REQUEST FOR FURTHER INFORMATION RESPONSE DOCUMENT
FOR ADAMSTOWN SDZ PLANNING APPLICATION:
ADERRIG PHASE 3
MARCH 2022

CONTENTS

Proposed Road 8

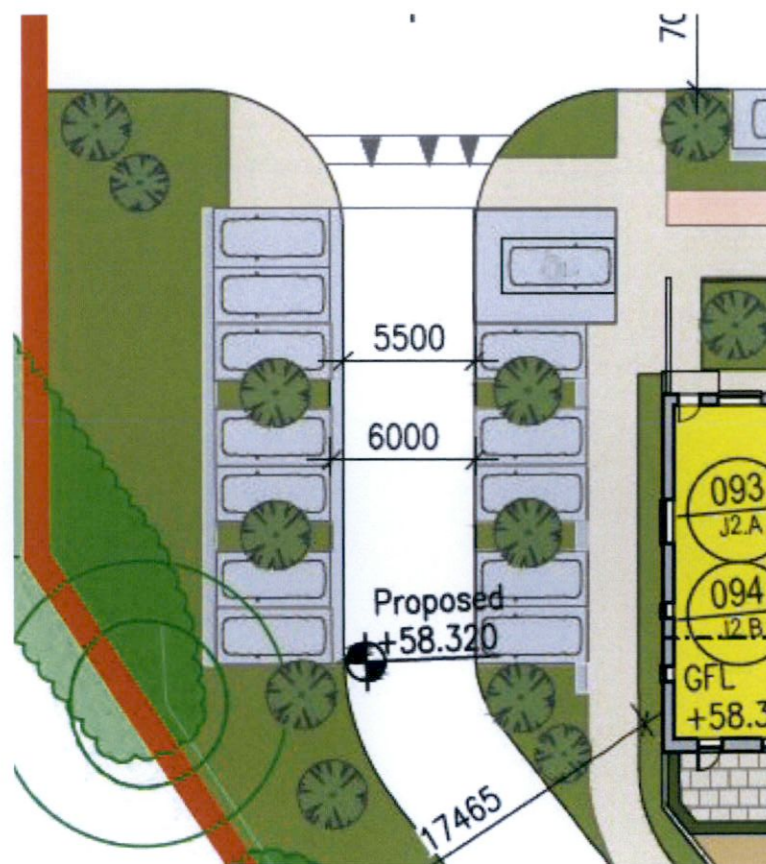
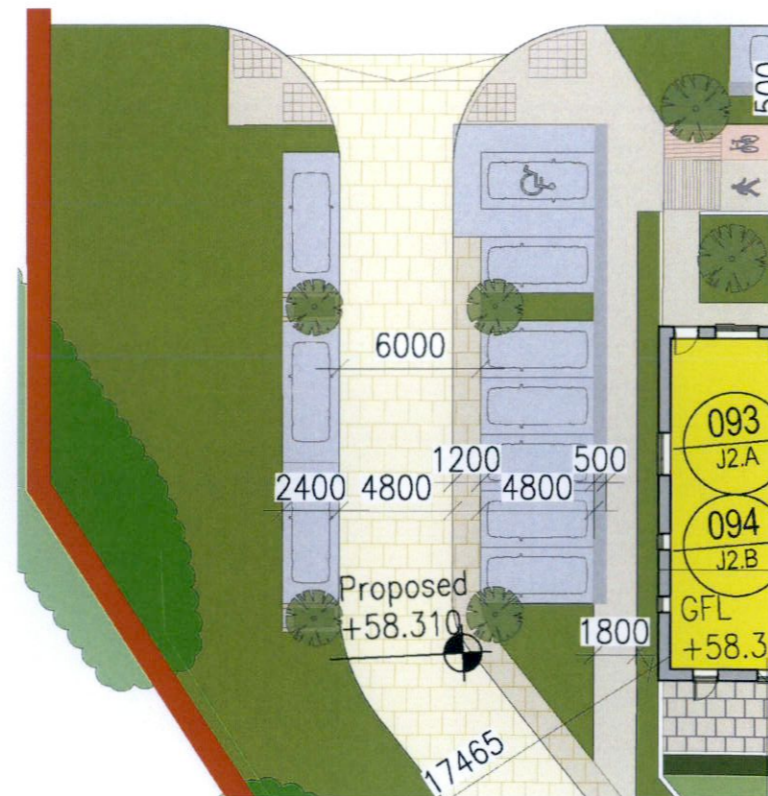
3.a. The applicant is requested to submit a revised layout showing perpendicular parking only being provided on one side of the street at any point. The applicant should also demonstrate a minimum distance of 6m behind each perpendicular parking space.

The site layout has been revised to show perpendicular parking only to one side of the street, always opposite parallel parking. See examples below and adjacent.

Road 4 - Cross Section

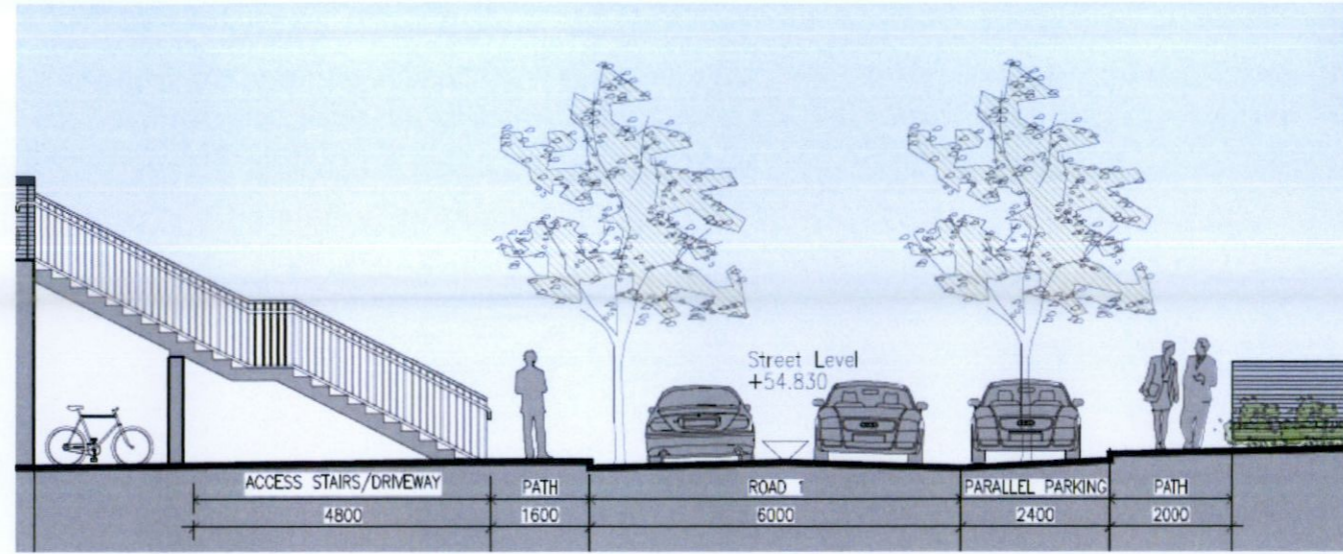
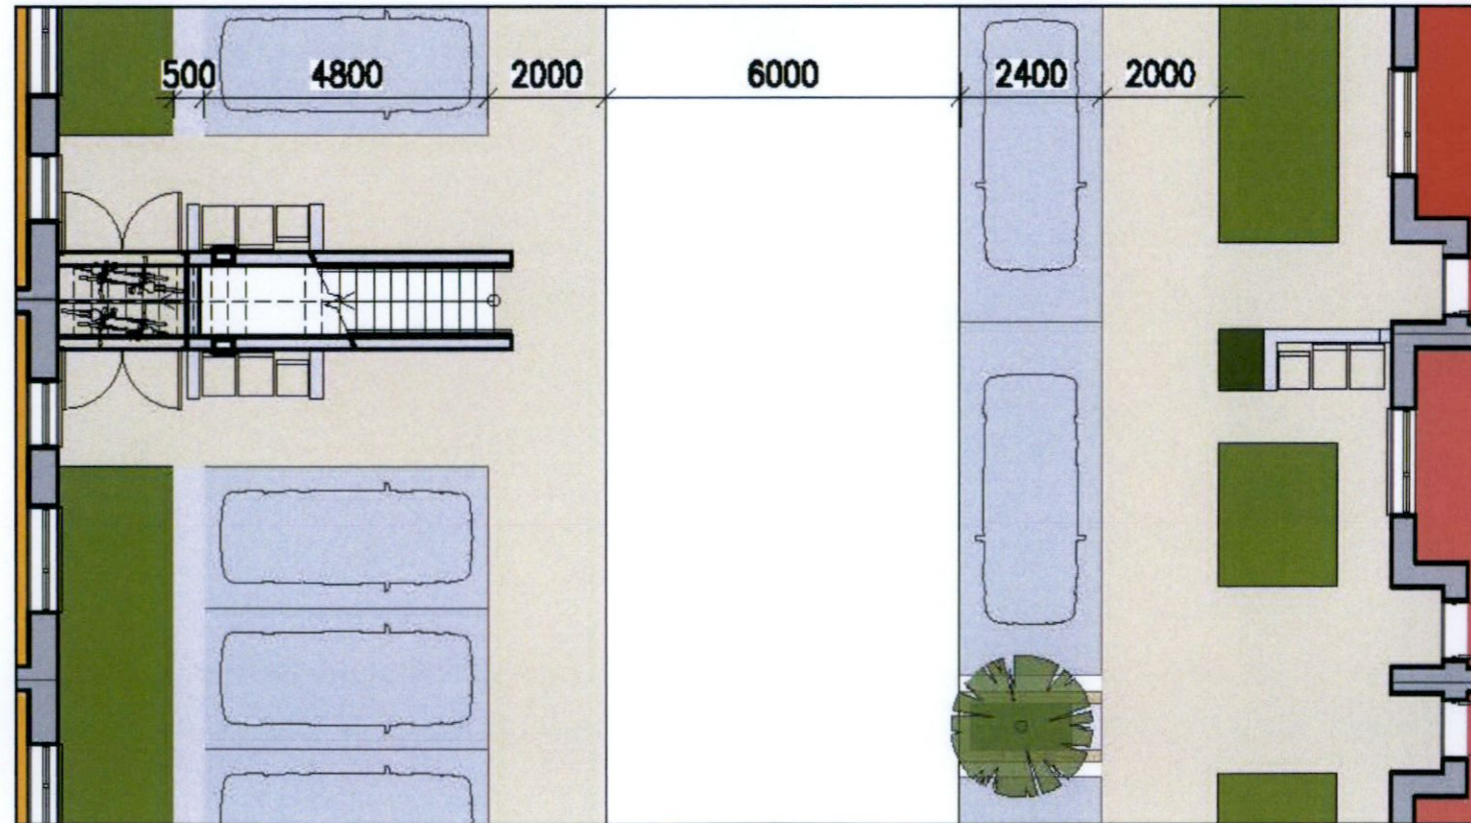
3.b. The applicant is requested to submit a revised layout not less than 1:200 scale showing the cross sections of the roads confirming the layouts as described in the SDZ planning scheme.

Please refer to drawing '6159A-P-30_Street Sections' which illustrates the road cross sections provided for Roads 1-7. See also example below & '6159A-P-10 & 6159A-P-11 Site Block Plans' for further detail.

3.d Pedestrian & Cycle Link to Local Park

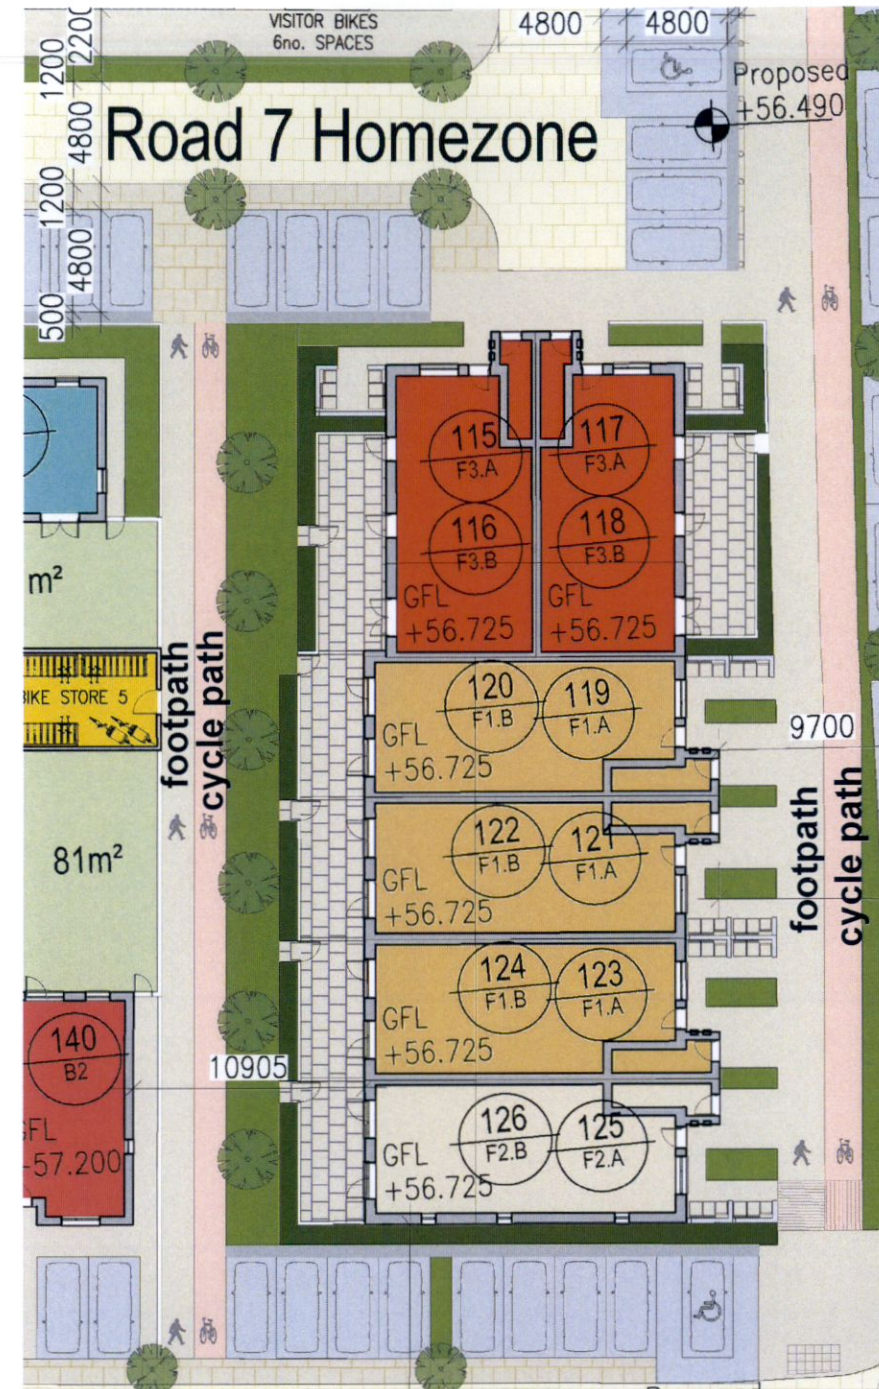
3.d. The applicant I requested to the provide a pedestrian and cycle link from the South West corner of development to the Local Park, in lieu of the linear area of communal open space that runs between Road 9 and Homezone 1.

A pedestrian and cycle link has been added to connect Road 9 with the local park. This runs along the west of the 'additional open space' provided at the rear of the duplex units.

Proposed Hierarchy of Streets

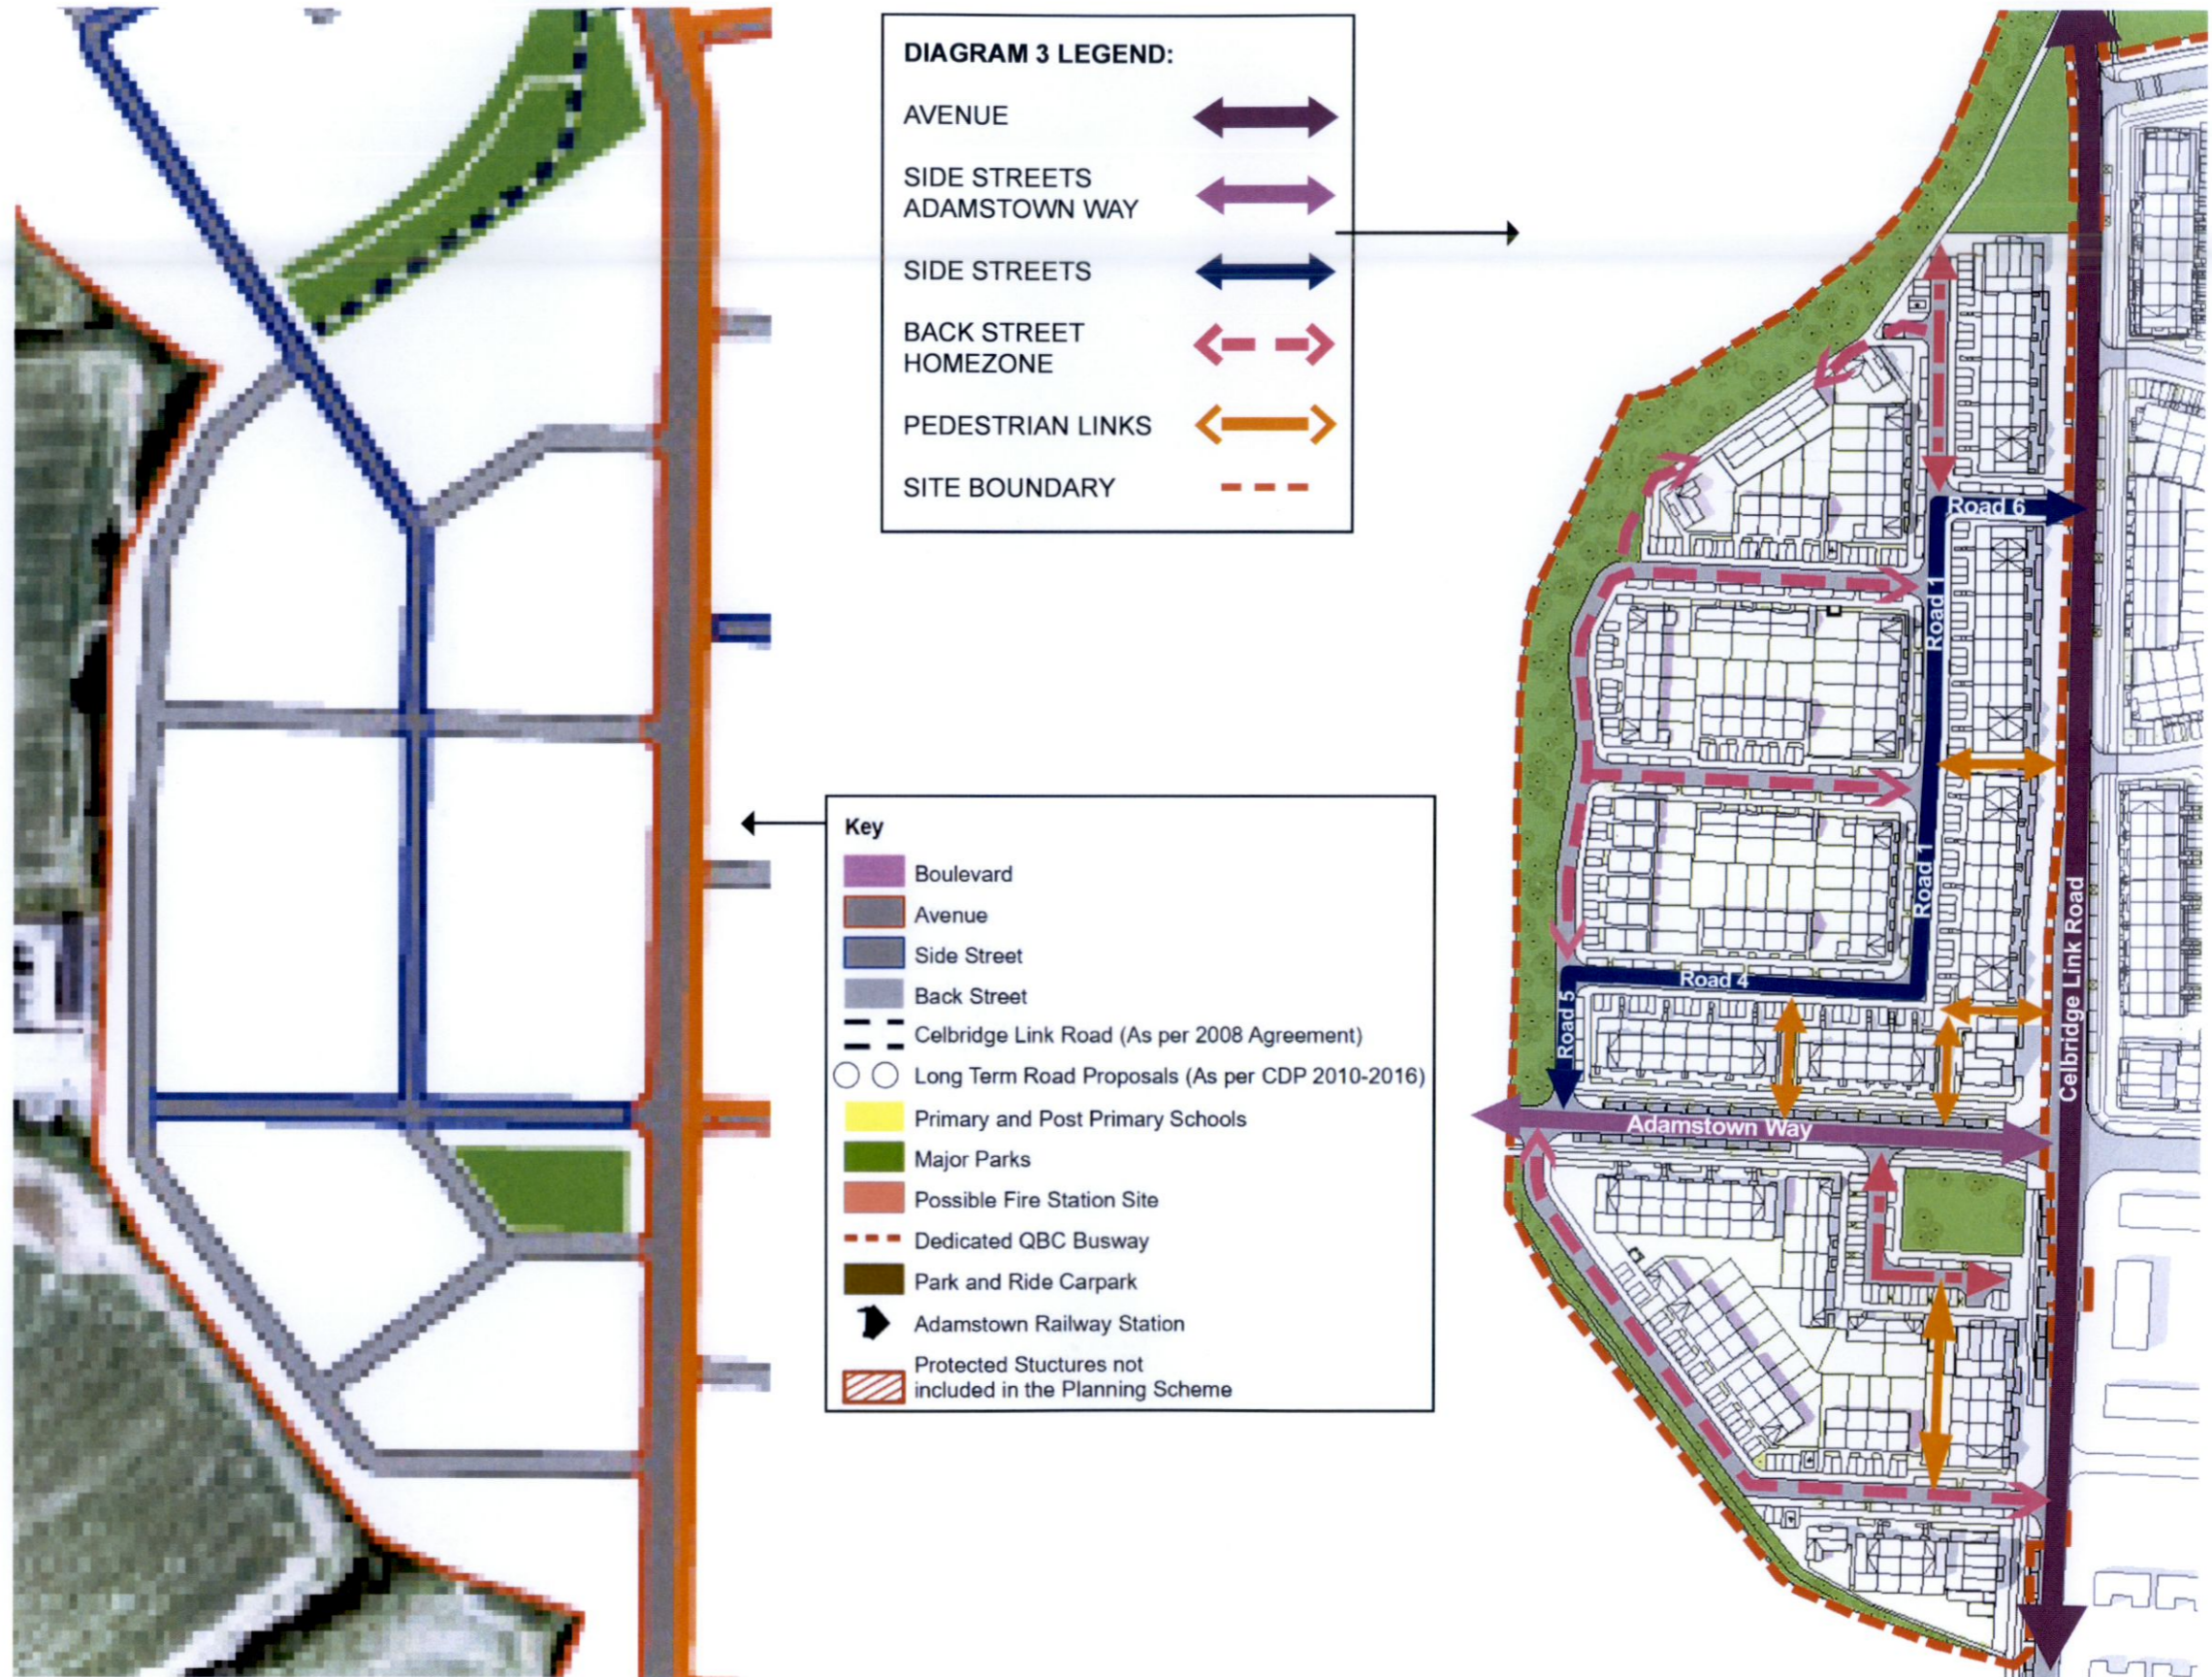
3. The applicant should note that all roads should be designed in accordance with the Adamstown Street Design Guide. The applicant is requested in the additional information submission to set out the road typology and design parameters used that are in accordance with the ASDG.

A full review has been undertaken of the proposed street design to follow the ASDG with a small number of deviations where necessary. See adjacent diagram showing the proposed street hierarchy in comparison to the SDZ diagram.

In the SDZ diagram, one Side Street is shown connecting Adamstown Way to the adjacent site to the north. A connection through the boundary hedgerow here is not possible, as there was no allowance made for this in the planning application to the north of the hedgerow. Instead we have shown connecting out east onto the Celbridge Link Road.

The SDZ diagram shows 2no. streets branching north off Adamstown Way. The proposed design instead shows 1no. street and 2no. pedestrian routes. This is supported by traffic models.

The SDZ diagram shows 2no. street branching off Celbridge Link Rd. to the north of Adamstown Way. The proposed design instead shows 1no. street and 2no. dedicated pedestrian routes, plus an additional pedestrian connection via the public open space to the north of the site. This follows the Celbridge Link Rd. as it was already constructed.
